Addendum 82: Regulation No. 83

Revision 4 – Amendment 2

Supplement 2 to the 06 series of amendments to the Regulation - Date of entry into force:
13 April 2012

Uniform provisions concerning the approval of vehicles with regard to the emission of pollutants according to engine fuel requirements

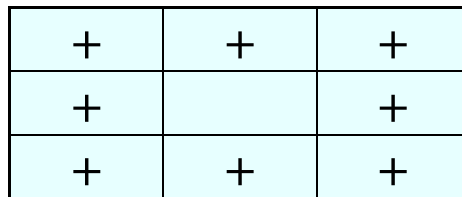
Paragraph 6.1.3., amend to read:

The above mentioned air velocity shall be determined as an averaged value of a number of measuring points which

- (a) For blowers with rectangular outlets are located at the centre of each rectangle dividing the whole of the blower outlet into nine areas (dividing both horizontal and vertical sides of the blower outlet into three equal parts). The centre area shall not be measured (as shown in the diagram below).

"6.1.3. A current of air of variable speed shall be blown over the vehicle. The blower speed shall be within the operating range of 10 km/h to at least the maximum speed of the test cycle being used. The linear velocity of the air at the blower outlet shall be within ± 5 km/h of the corresponding roller speed within the range of 10 km/h to 50 km/h. At the range over 50 km/h, the linear velocity of the air shall be within ± 10 km/h of the corresponding roller speed. At roller speeds of less than 10 km/h, air velocity may be zero.

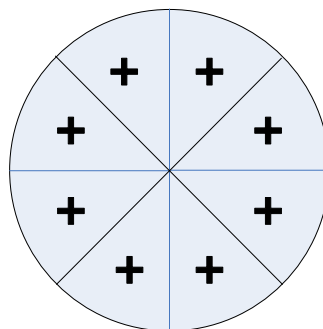
- (b) For circular blower outlets, the outlet shall be divided into eight equal arcs by vertical, horizontal and 45° lines. The measurement points lie on the radial centre line of each arc (22.5°) at a radius of two thirds of the total (as shown in the diagram below).

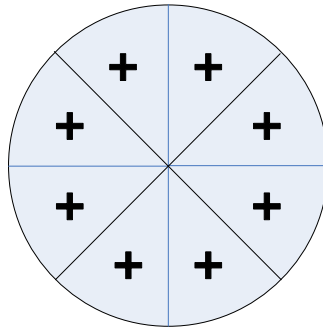
Paragraph 3.4.2., amend to read:

- (a) For blowers with rectangular outlets are located at the centre of each rectangle dividing the whole of the blower outlet into nine areas (dividing both horizontal and vertical sides of the blower outlet into three equal parts). The centre area shall not be measured (as shown in the diagram below).

- (b) For circular blower outlets, the outlet shall be divided into eight equal arcs by vertical, horizontal and 45° lines. The measurement points lie on the radial centre line of each arc (22.5°) at a radius of two thirds of the total (as shown in the diagram below).

"3.4.2. A current of air of variable speed shall be blown over the vehicle. The blower speed shall be, within the operating range of 10 km/h to at least the maximum speed of the test cycle being used. The linear velocity of the air at the blower outlet shall be within ± 5 km/h of the corresponding roller speed within the range of 10 km/h to 50 km/h. At the range over 50 km/h, the linear velocity of the air shall be within ± 10 km/h of the corresponding roller speed. At roller speeds of less than 10 km/h, air velocity may be zero.
